161 Alden Road, Units 7 & 8, Markham, Ontario Canada L3R 3W7 Tel: +1 416 754-3322 Fax: +1 416-754-3299 Email: support@edac.net http://www.edac.net ENGINEERING CHANGE NOTICE		
Originator:	Mit Patel	Date:	Document Number
Phone No.	416-754-3322	April 4, 2025	20250404-00
Email Address:	mpatel@edac.net	Revision Number	SHEET
Department	Quality	1	1 of 3

DESCRIPTION OF CHANGE:

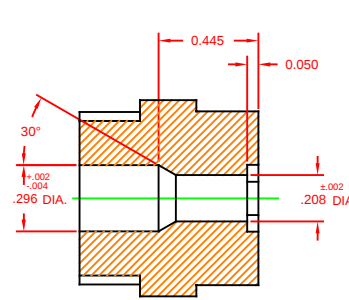
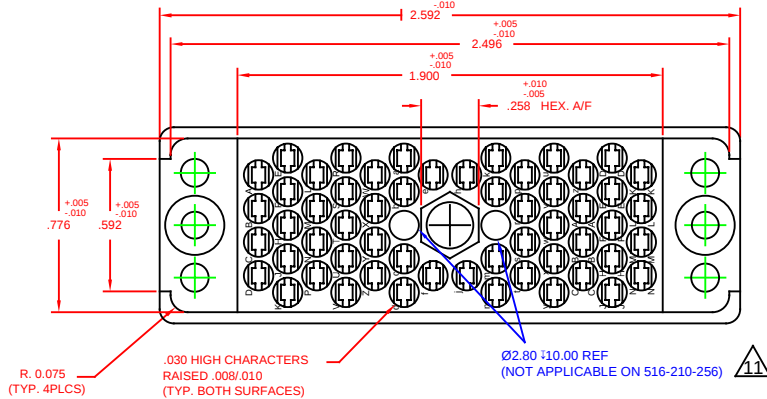
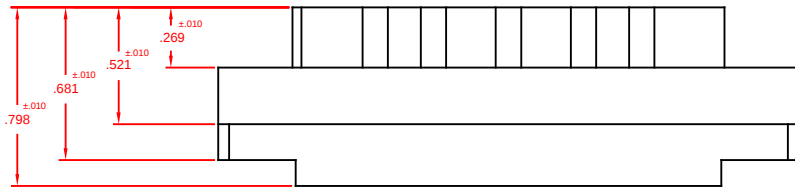
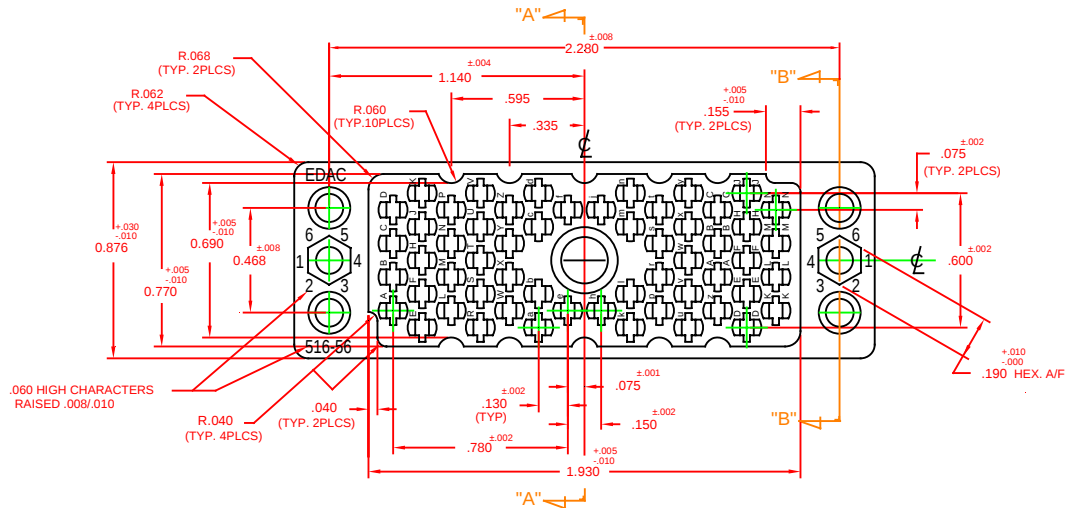
Reference dimension Ø2.80 ~~110.00~~ has been added to the new revision 516-210-156 (Revision 11). Please see the image below. There will be no form, fit, or function effects due to this change. This is to eliminate sink marks on the insulation. Please note that this dimension is **not applicable** for Plug 516-210-156 and Receptacle 516-210-256 that use DAP material.
